U.S. NUCLEAR REGULATORY COMMISSION
Office of Nuclear Material Safety and Safeguards
Spent Fuel Project Office

CONFIRMATORY ACTION LETTER 97-7-001
TECHNICAL EVALUATION

Docket No: 72-1007

Certificate Holder: Sierra Nuclear Corporation
One Victor Square
Scotts Valley, CA 95066

Figure A1

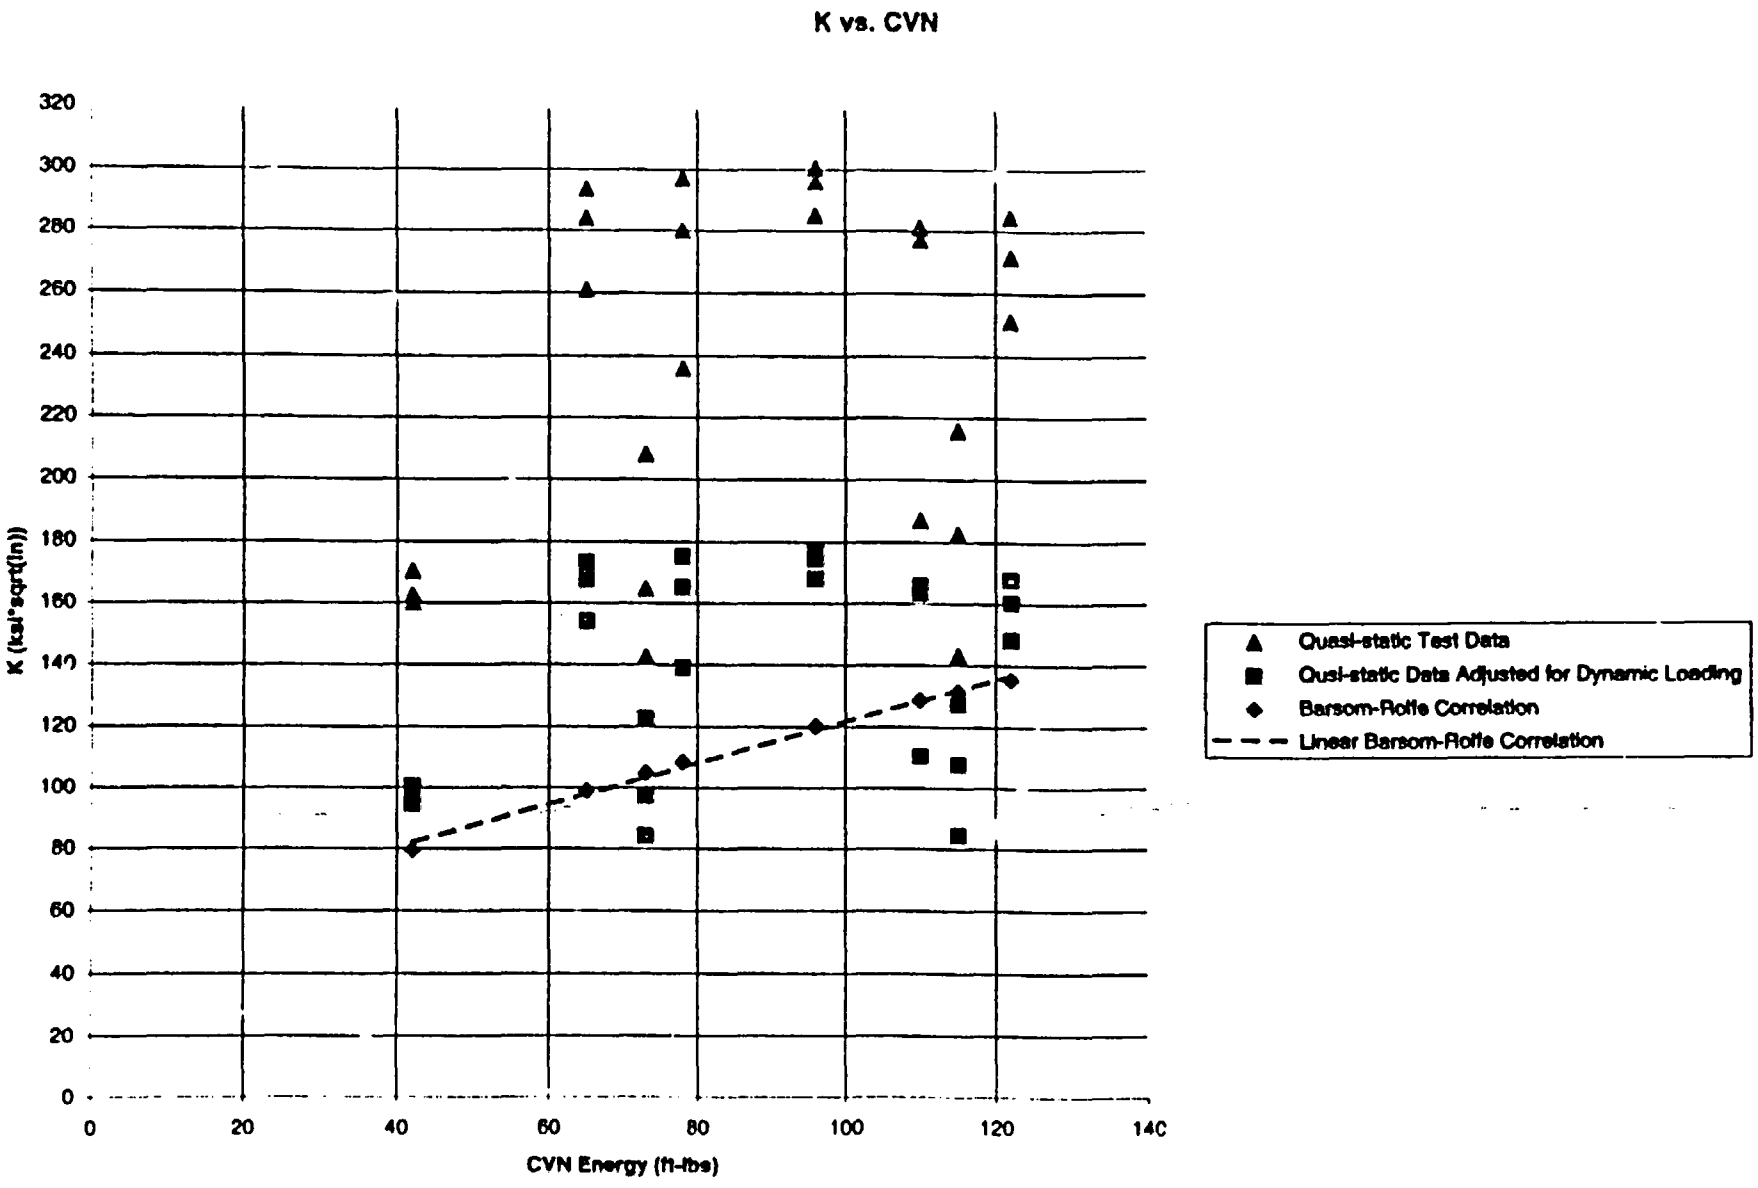
The staff plotted the data for fracture toughness and CVN provided by the Owners Group (Figure A1). The staff did not observe any relationship between K_{IC} and CVN in the data presented and concluded that the Barsom-Rolfe correlation for the MSB material was inappropriate. This staff position was documented in the May 21, 1998, letter from NRC to SNC.

In its independent evaluation, the NRC staff considered fracture toughness data generated by both the Owners Group and NSWC and used the following approach to arrive at a limiting fracture toughness of 53 ksi$\sqrt{\text{in}}$ for a temperature of 0°F:

Figure B1

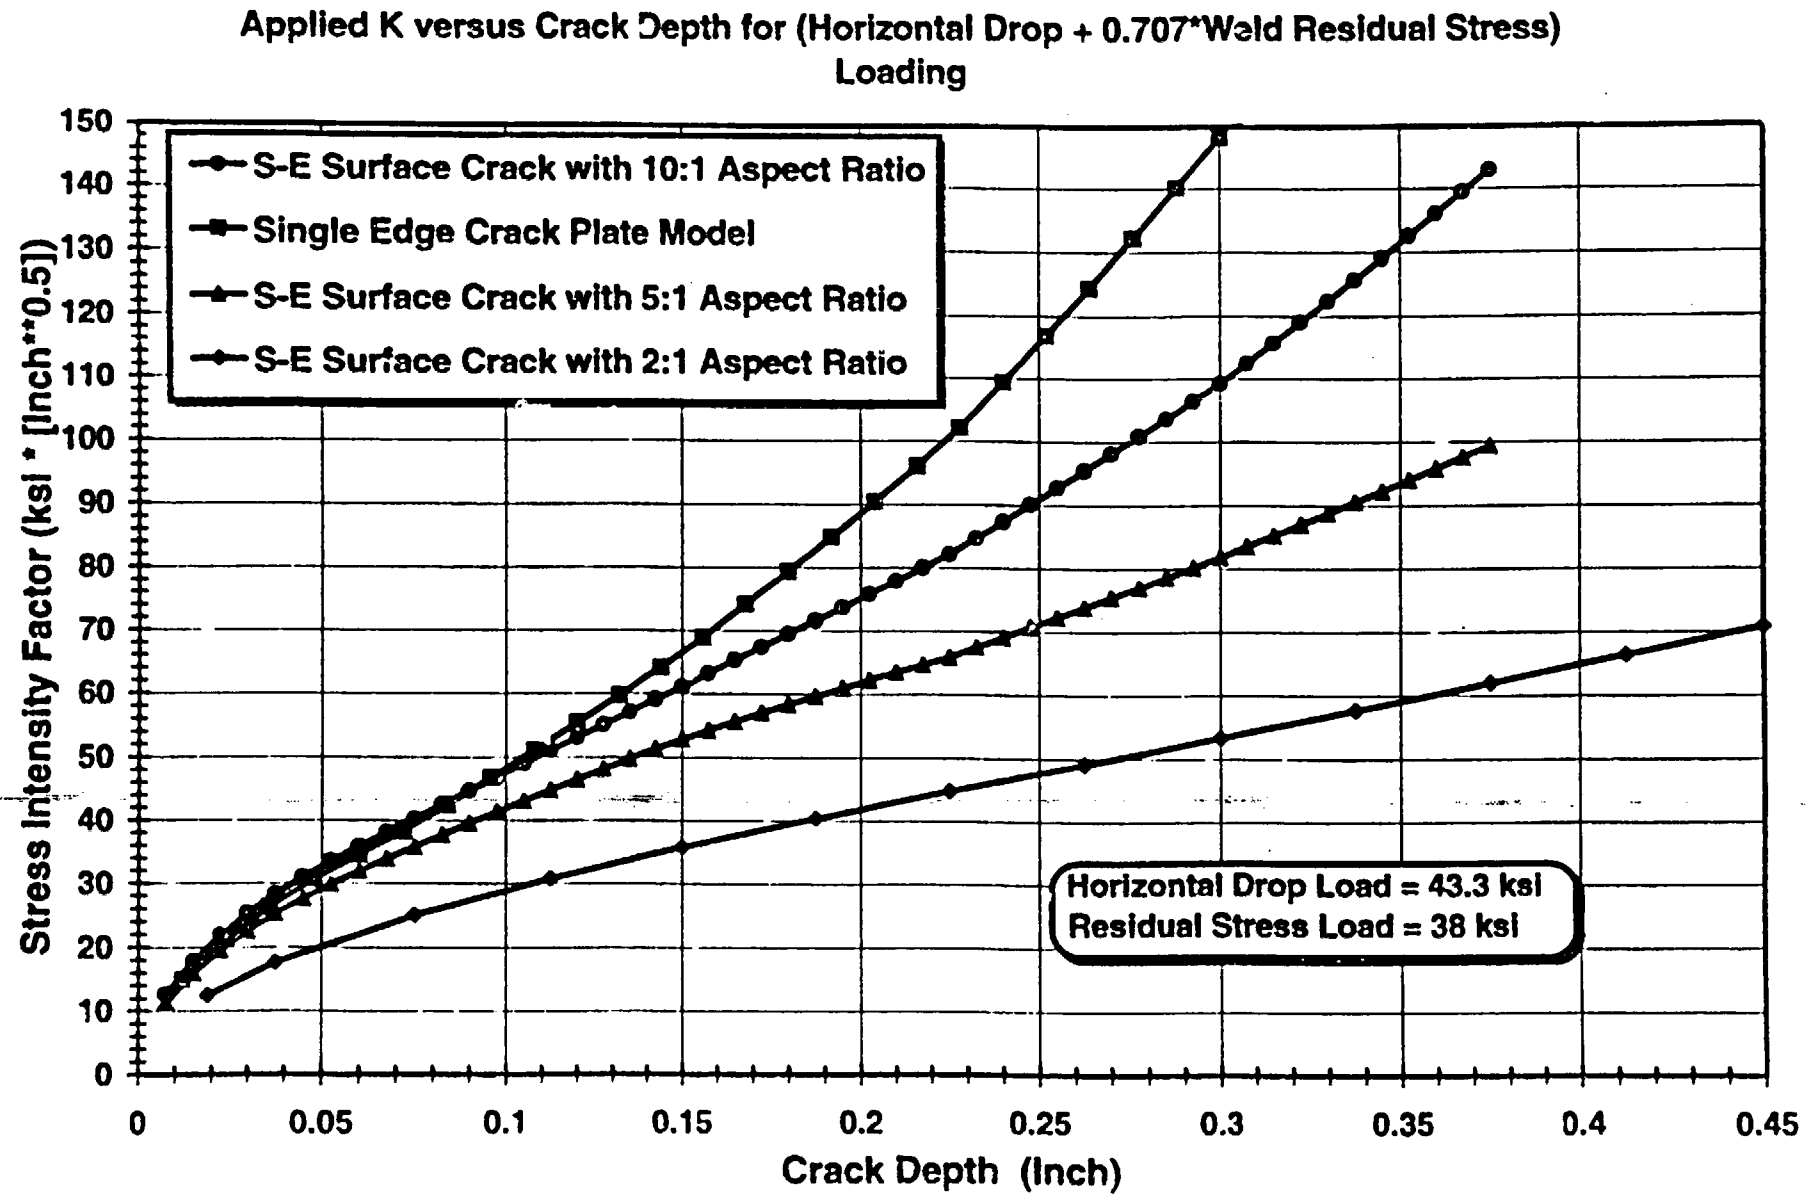
Figure B1 shows the maximum stress intensity factors (K_I) for the semi-elliptical cracks with aspect ratios, a/c, of 0.5, 0.2, 0.1 and 0 SECP, as a function of the crack depth. It can be seen that as the aspect ratio, a/c, value decreases from 0.5 to 0, the crack driving force (K_I) values increase with the SECP (i.e., for a/c = 0) being the highest value for any given crack depth.

Figure B2

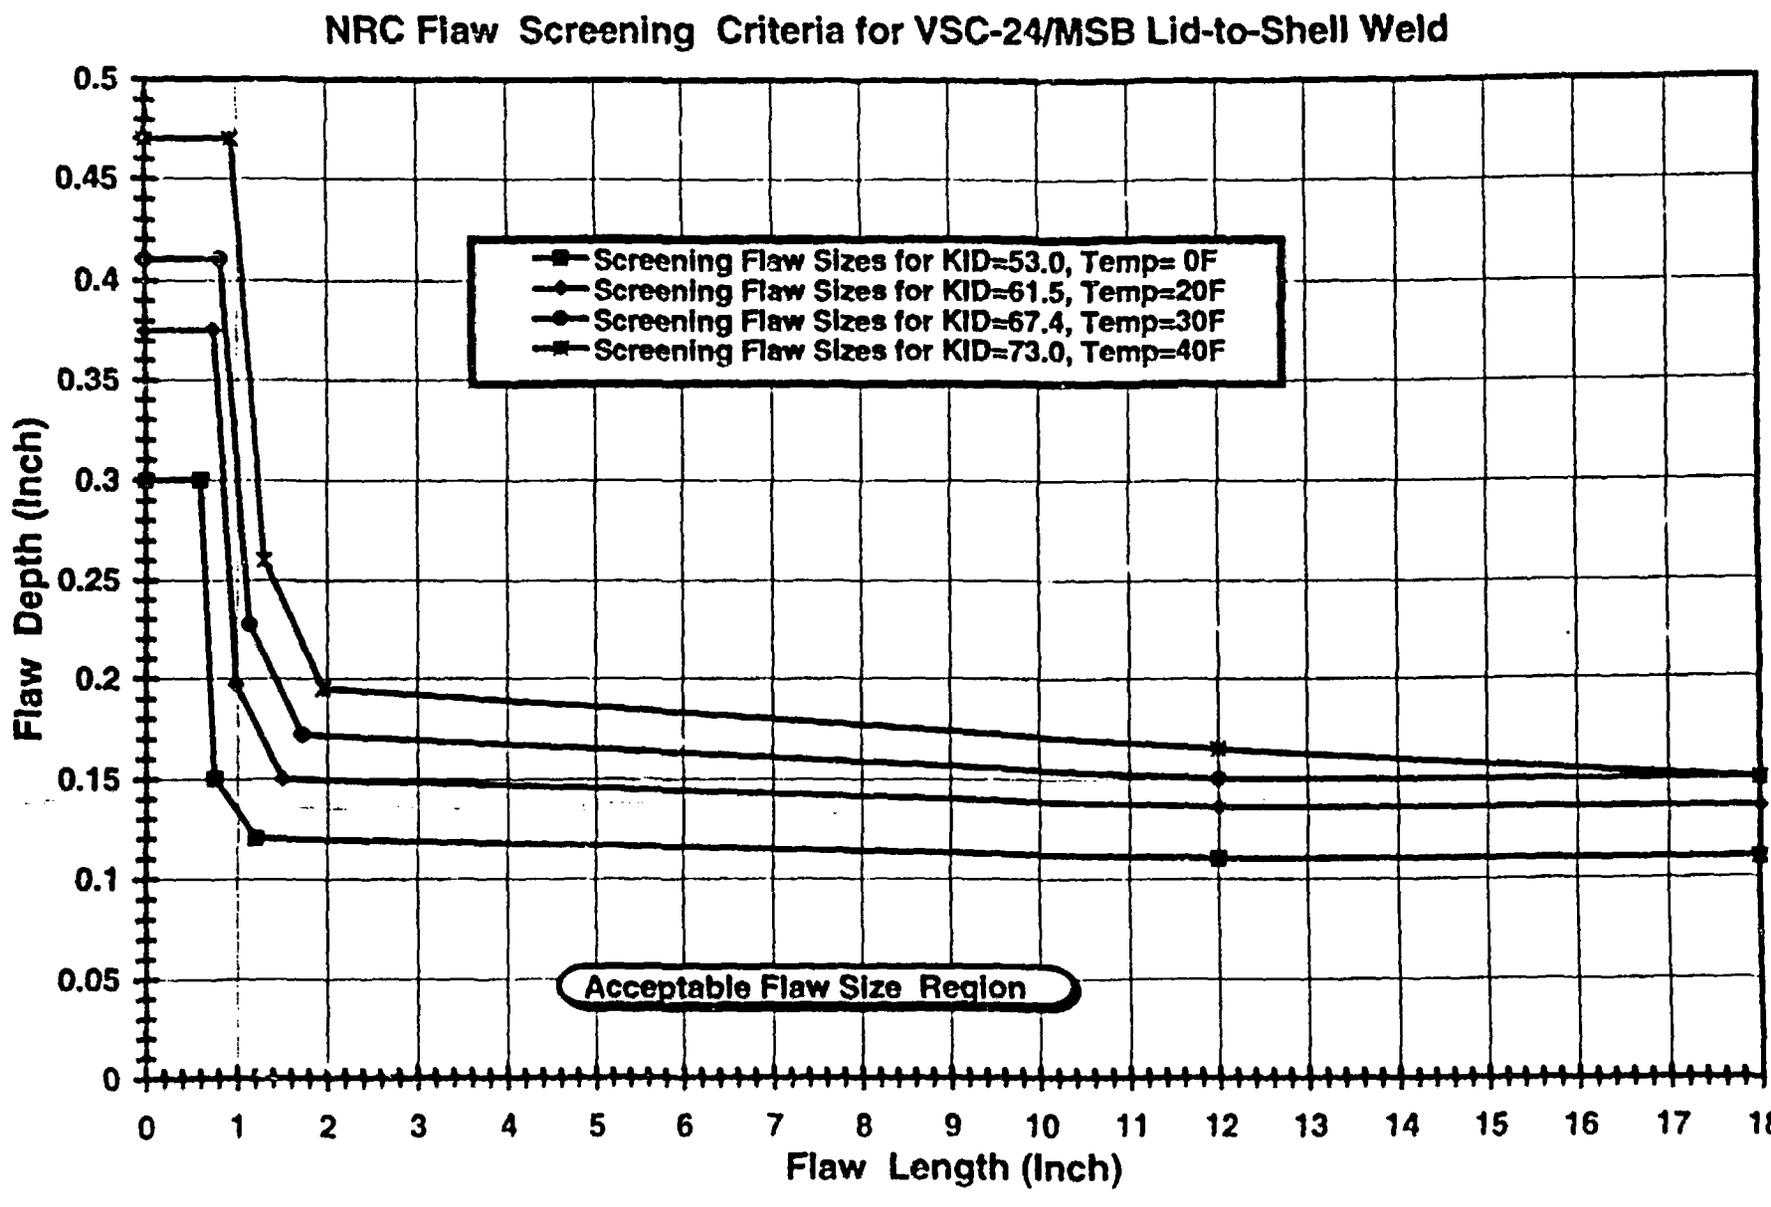
Flaw screening criteria to prevent cleavage crack propagation were determined on the basis of bounding estimates of dynamic fracture toughness (K_{ID}) values at assumed minimum closure weld service temperatures, as shown in Appendix A, Table A1. The flaw screening criteria (depths and surface lengths) criteria for semi-elliptical surface-breaking flaws are shown in Figure B2. For flaw lengths that are 18 inches or less (i.e., about 10% of the MSB shell circumference), the primary stress limits of NB-3000 are not exceeded, per Paragraph IWB-3610 (d) (2) of Section XI to the ASME Code (1989).
